**CITY AND COUNTY OF DENVER
DEPARTMENT OF TRANSPORTATION AND INFRASTRUCTURE**

**CONTRACT NO. 202582578
PROJECT NAME: Tennessee & Oneida Storm System Phase 3**

**ADDENDUM NO. 3 TO CONTRACT DOCUMENTS
DATE OF ADDENDUM: 02-17-2026**

DRAWN BY:	JRR
DESIGNED BY:	SRP
APPROVED BY:	SRP
DRAWING NAME:	PAVING TENN-ONEIDA PH3.dwg
DATE:	NOV 2025
SHEET NO.:	17 OF 28

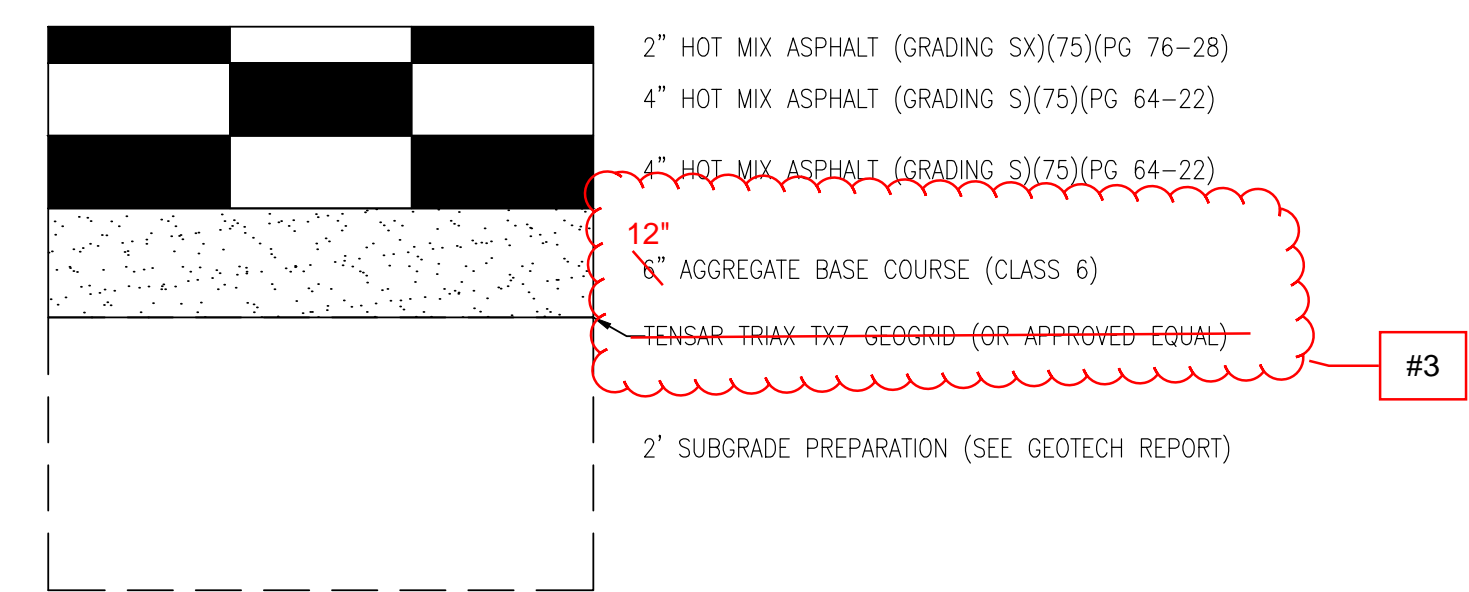
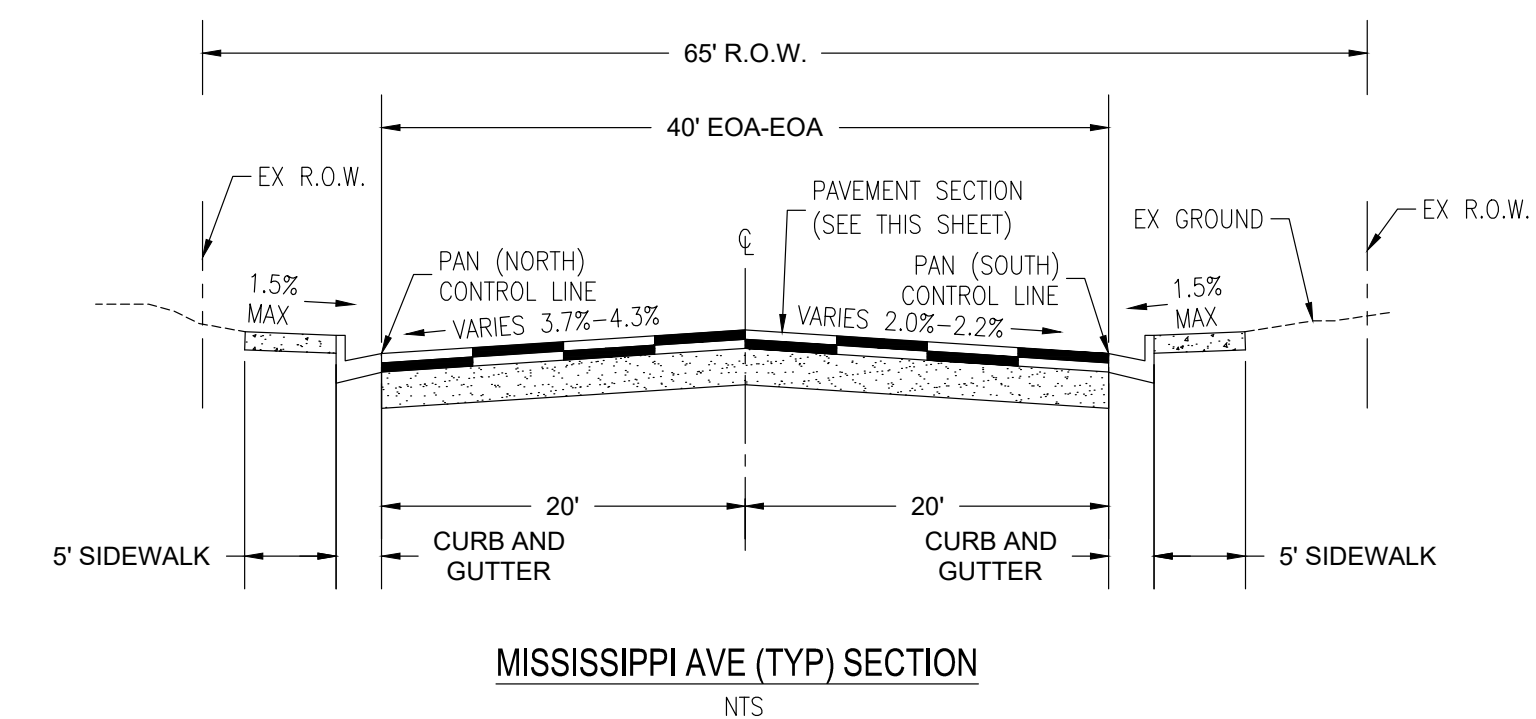
FULL DEPTH PAVEMENT SECTION
MISSISSIPPI AVE EAST OF MONACO PKWY
FROM STA. 401+07.96 TO STA. 412+38.02

NO.	DESCRIPTION OF REVISIONS	DATE	BY
3	PAVEMENT SECTION REVISED	2/9/26	IEP

DRAWN BY: JRR
DESIGNED BY: SRP
APPROVED BY: SRP
DRAWING NAME: PAVING_TENN-ONEIDA_PH3.dwg
DATE: NOV 2025
SHEET NO.: 18 OF 28

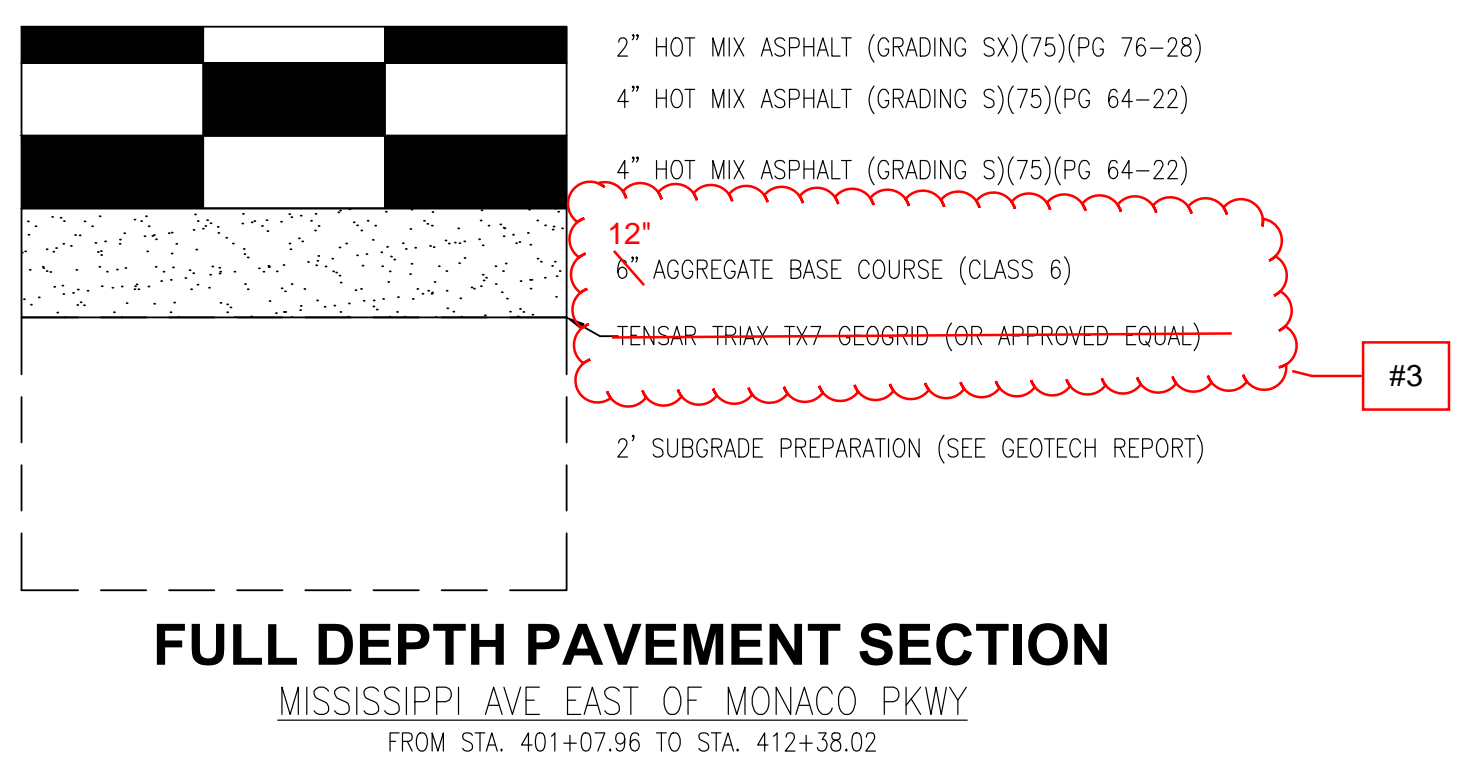
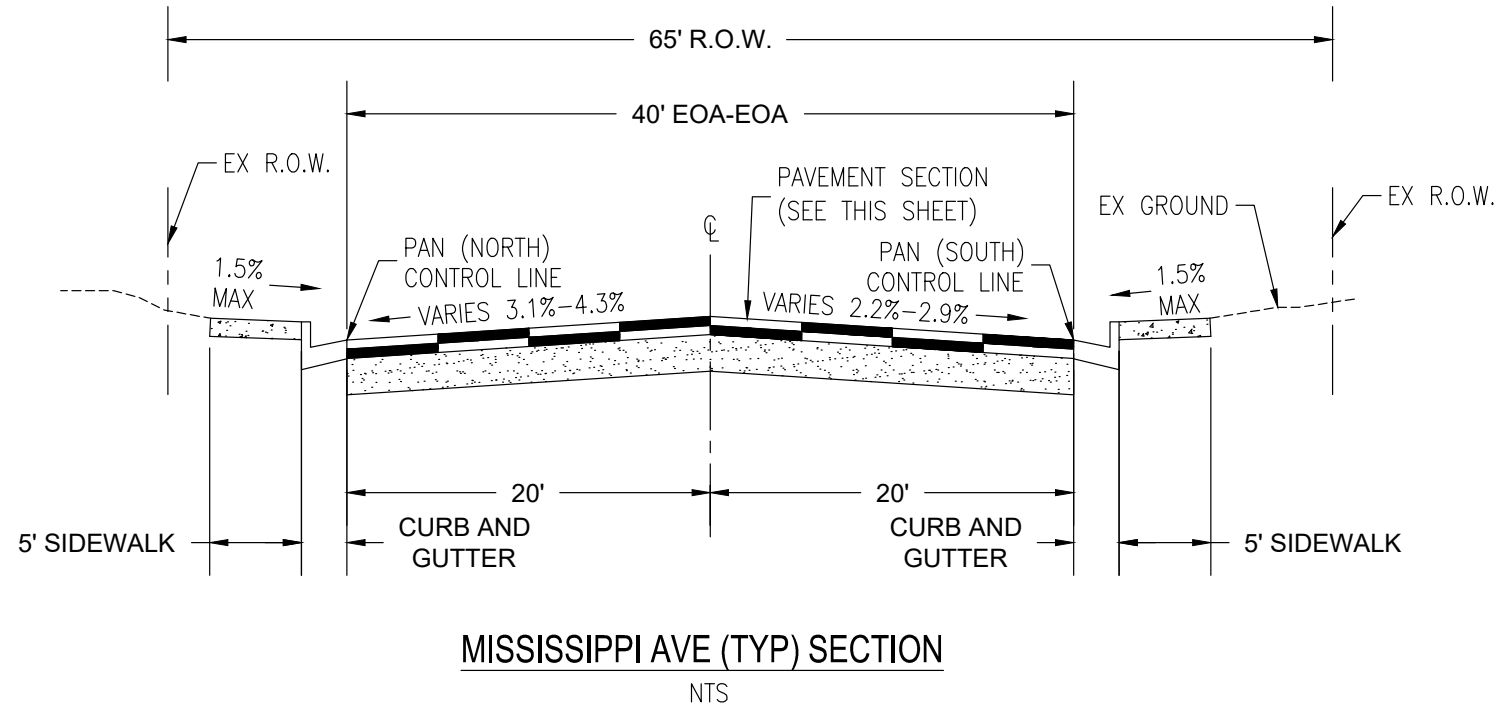
NO.	DESCRIPTION OF REVISIONS	DATE	BY
3	PAVEMENT SECTION REVISED	2/9/26	IEP

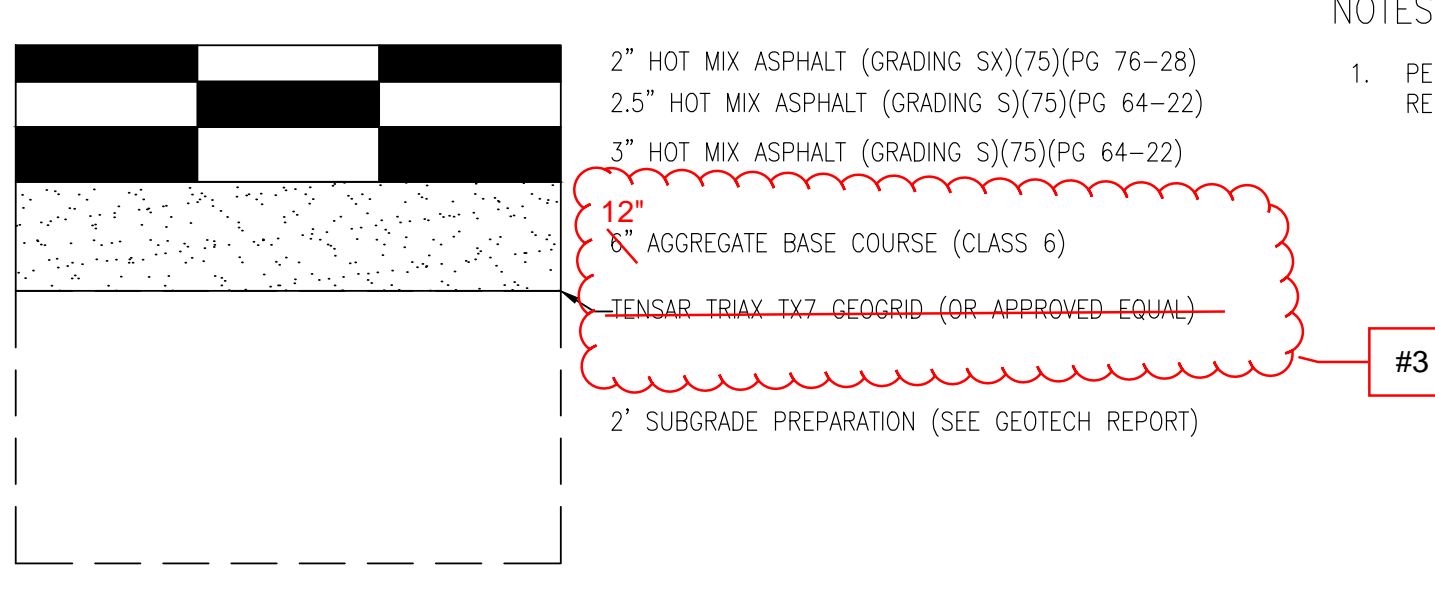
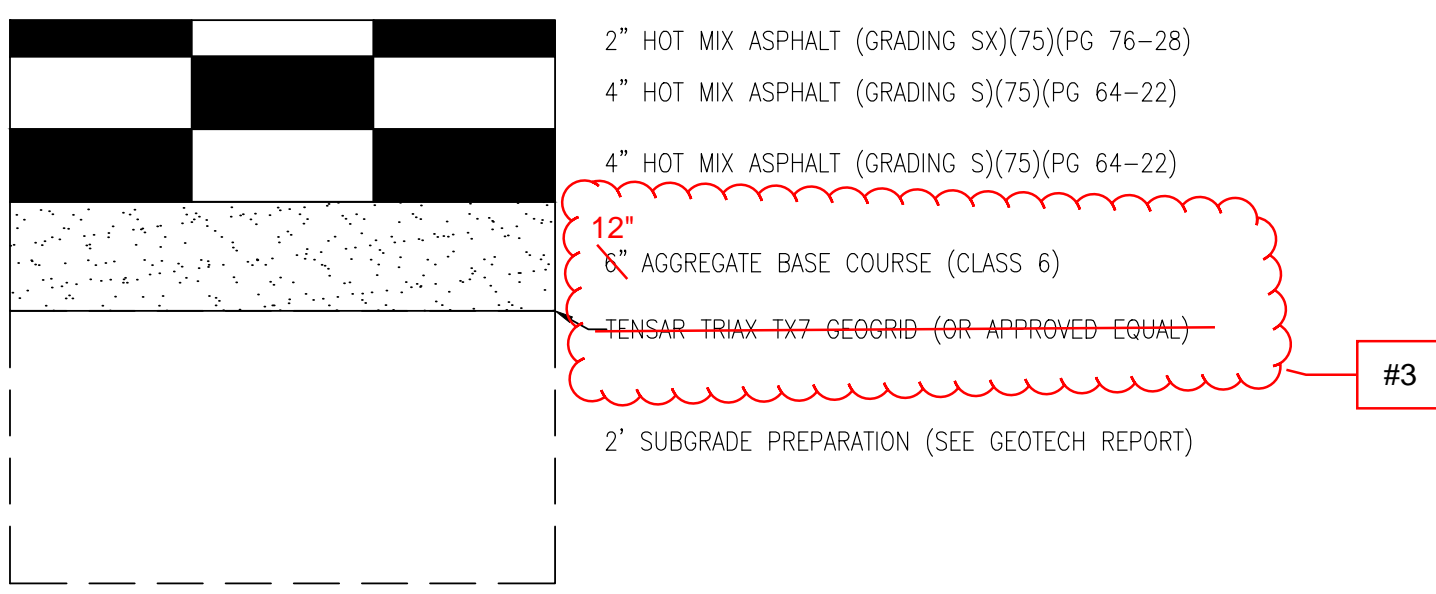
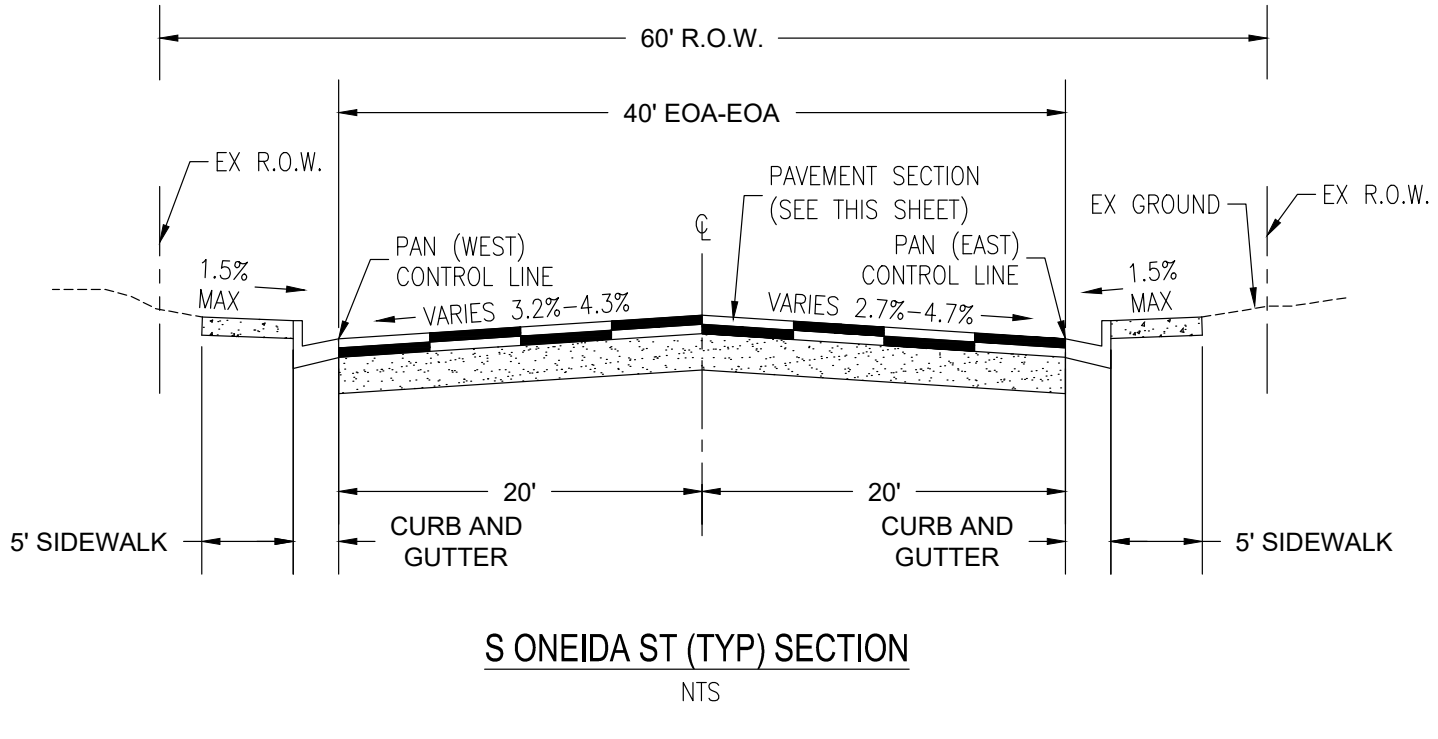
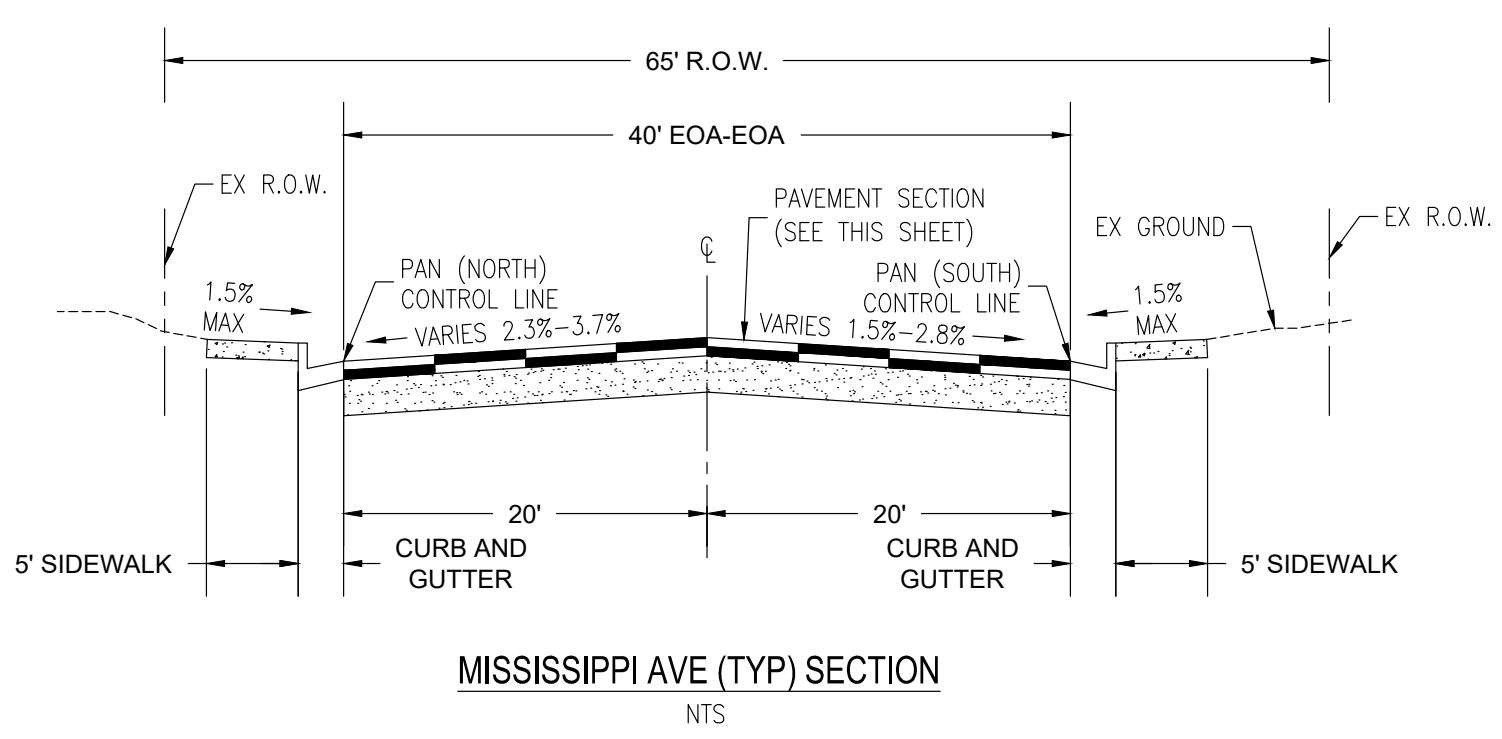
NO.	DESCRIPTION OF REVISIONS	DATE	BY
3	PAVEMENT SECTION REVISED	2/9/26	IEP
